Intersection ID: 10034609	Main Street: PLANTATION_CENTER_DR	Cross Street: N/A	Location:	S
ADA ID: CC3D4A428B01	Ramp Type: Para	Initial Pass/Fail: Fail	Overall Compliance: No	Severity Score: 13.75

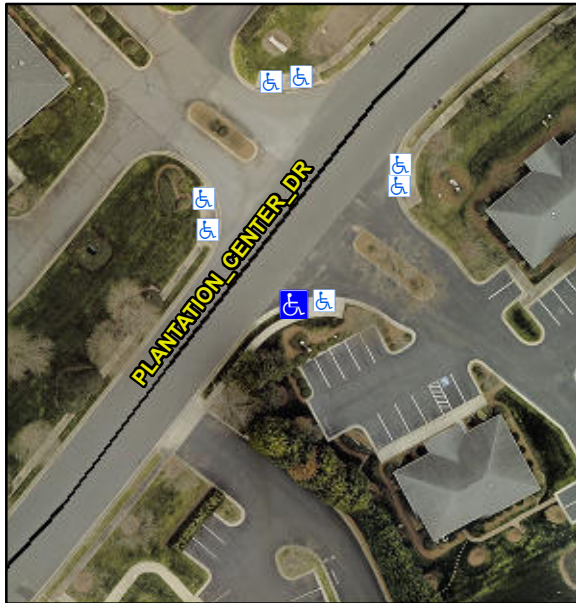
Possible Solutions:			Compliance	Description	Data	Compliance	Description	Data
<b>Remove &amp; Replace Entire Ramp.</b>			N/A	Ramp Length LT (in)	55.0	N/A	Ramp Length RT (in)	54.0
			Yes	Ramp Width LT (in)	97.0	Yes	Ramp Width RT (in)	97.0
			No	Ramp Slope LT (%)	11.2	Yes	Ramp Slope RT (%)	5.7
			No	Ramp XSlope LT (%)	4.3	Yes	Ramp XSlope RT (%)	1.2
			N/A	Landing Length (in)	N/A	N/A	DWS Provided?	N/A
			N/A	Landing Width (in)	N/A	N/A	DWS Contrast?	N/A
Surveyor Notes:			N/A	Landing Slope (%)	N/A	N/A	DWS Length (in)	N/A
	<b>N/A</b>		N/A	Landing X Slope (%)	N/A	N/A	DWS Full Width?	N/A
			N/A	Landing Curb? (Y/N)	N/A	N/A	DWS Offset (in)	N/A
			N/A	Shared Landing?	N/A			
			N/A	Gutter Ponding?	N/A	N/A	Gutter Slope (%)	N/A
PROW/ADA:			N/A	Gutter Lip Ht (in)	N/A	N/A	Gutter X Slope (%)	N/A
	<b>R304.3.2, R304.5.3</b>		N/A	Painted X Walk1?	No	N/A	Painted X Walk2?	N/A
				X Walk 1 Direction	To NW		X Walk 2 Direction	N/A

N/A	X Walk 1 Width (in)	N/A	N/A	X Walk 2 Width (in)	N/A
				X Walk 1 Slope (%)	3.4		X Walk 2 Slope (%)	N/A
				X Walk 1 X Slope (%)	0.4		X Walk 2 X Slope (%)	N/A
			N/A	Ramp inside XWalk1?	N/A	N/A	Ramp inside XWalk2?	N/A
				Road Slope (%)	N/A	N/A	Clear Space?	N/A
				Road X Slope (%)	N/A	N/A	Clear Space to XWalk (in)	N/A
			N/A	Any Obstructions?	N/A	N/A	Storm Grate/Utility Hazard?	N/A
				Obstruction Type			Storm Grate/Utility Type	
Total Cost:	\$	1600.00			N/A			N/A
						Yes	Surface Condition? (G/P)	Good
						N/A	Curb Slope (%)	8.5

### Remove & Replace Entire Ramp.
